Application No. 10/542,898  
Paper Dated: September 5, 2007  
Reply to Office Communication of March 6, 2007  
Attorney Docket No. 0702-052257

### **IN THE DRAWINGS**

FIG. 5

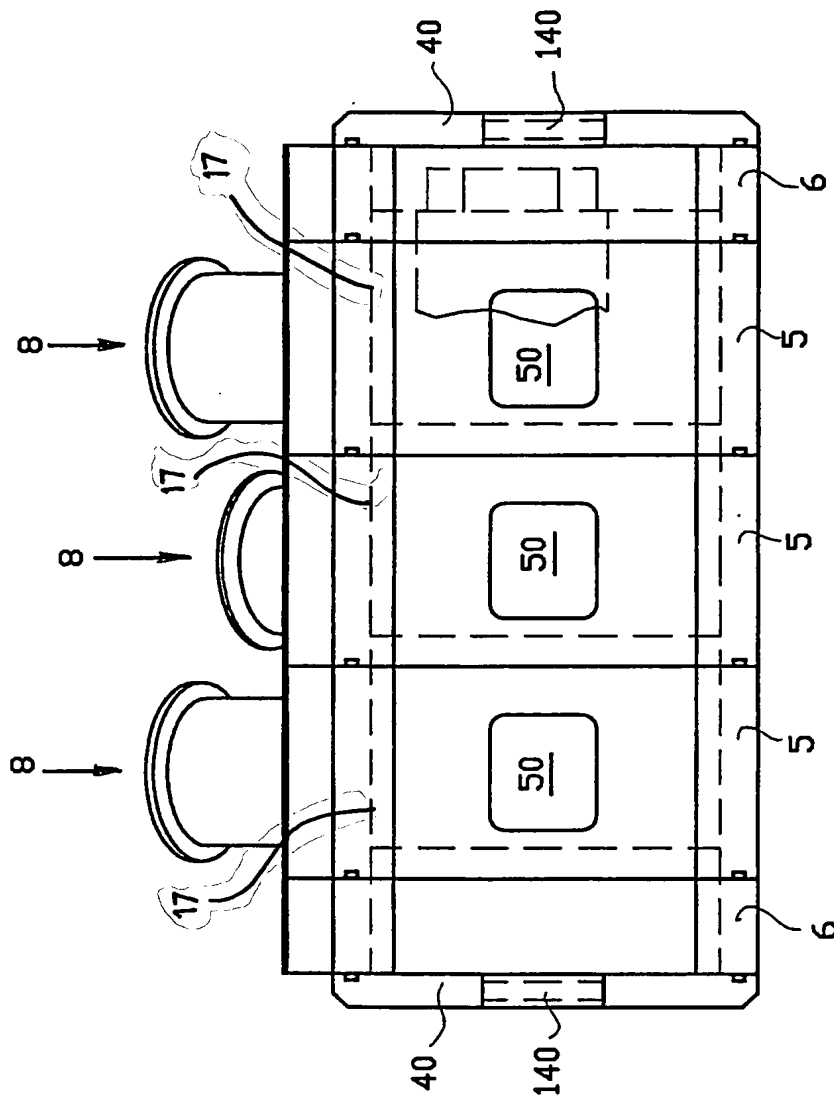
Please replace the originally-filed sheets of drawings containing Figs. 5-7 with the Replacement Sheets of Figs. 5-7. These replacement figures identify the cylinder 17 as described in the paragraph added in the foregoing "Amendments to the Specification" section above. No new matter has been added.

The Examiner has also objected to the drawings under 37 C.F.R. § 1.83(a) as not showing every feature of the invention specified in the claims. In particular, the Examiner notes that the "cylinder" recited in claims 28-30 is not present in the drawings. Applicant respectfully submits that the "cylinder" was and is illustrated in the drawings, but was not specifically referred to by a reference character. Therefore, reference character "17" has now been used to refer to the cylinder, and the specification has been appropriately amended to support this drawing modification. Entry of the amendments to the drawings, i.e., Figs. 5-7, and the specification is respectfully requested. These modifications address and overcome the Examiner's objection to the drawings in this regard.
